Safety Recall Trucks

Date	Group.	No.	Page
06.14	SC0380		1(6)

Safety Valve Missing From
Vertical Mounted Air Tank
CXU

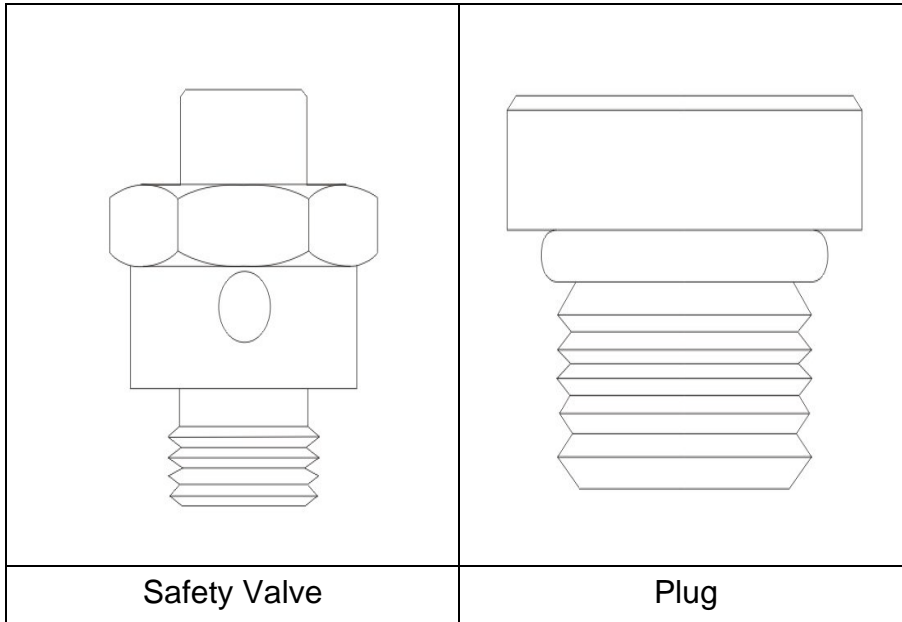
If the safety valve (part number 21608472) is missing and a plug (1) (part number 20590987) is installed, proceed to Repair step 1.

NOTE: The location of the safety valve is between the back of the cab (BOC) and the vertical tank.

1 - M16 Plug

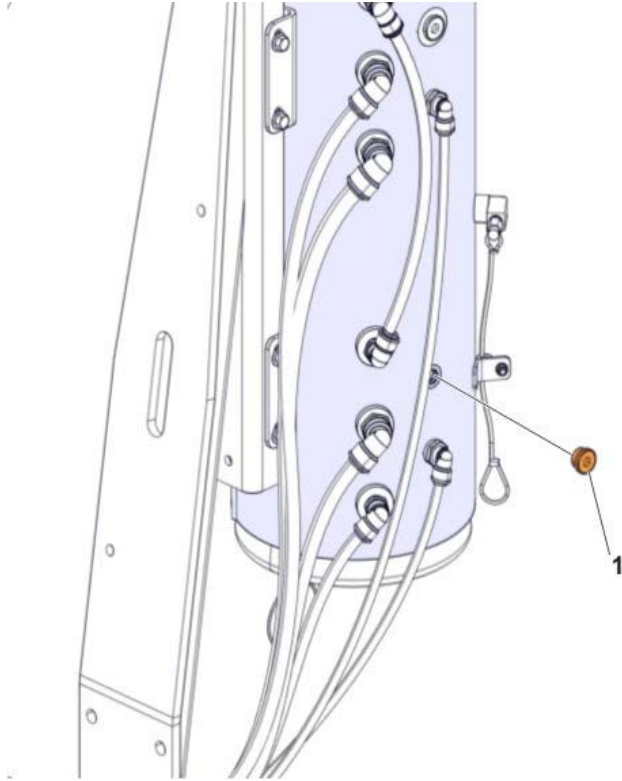
1. Drain the air system.
2. Remove the M16 plug fitting (1) [part number 20590987] and discard.

1 - Safety Valve

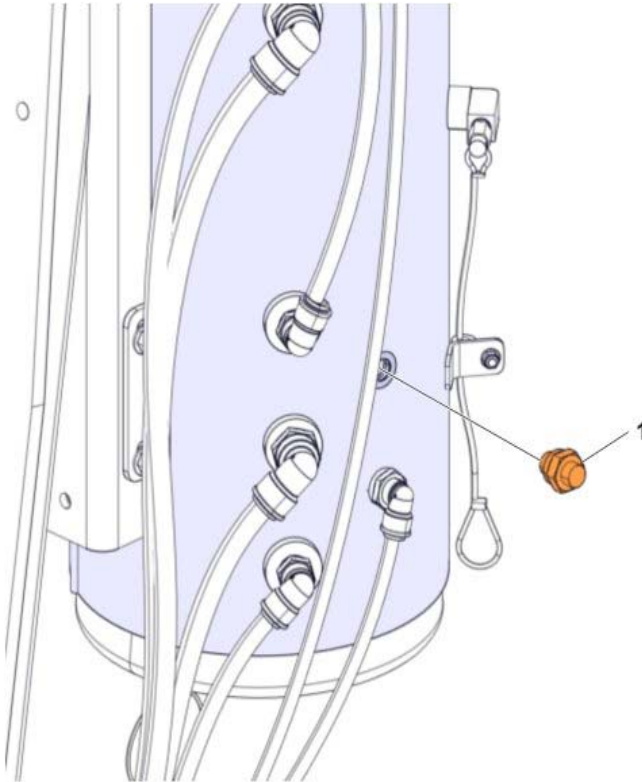
3. Install the safety valve (1) [part number 21608472]. Torque the safety valve to 27 +/- 2 Nm (20 +/- 1.5 ft-lb).
